Modification to run CPU09CMI on 4MHz bus.

9001-11641000

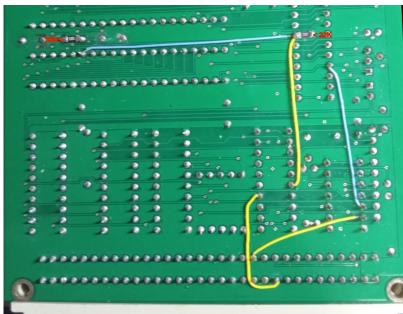
Now we need the Q clock on the 09FLP

Replace xtal into 16MHz. Replace C1 and C2 by 15pF. Place 10M smd between crystal pins. Replace GAL CMI_1 by CMI-4_1 Only use the HD63C09.

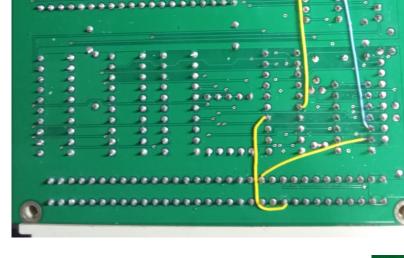
On top side:

Cut trace between U4-14 and J1 C-21 (B_VMA) For REV:0.9 print only cut trace from J1 A23 to R15

On solder side:

Cut trace between U13-19 and via (OVMA) Place 22K resistor between U13-19 and Gnd Place wire from U6-35 to U13-19 and U4-6 (O) Place wire from U4-14 to J1 A-23 (B_Q)
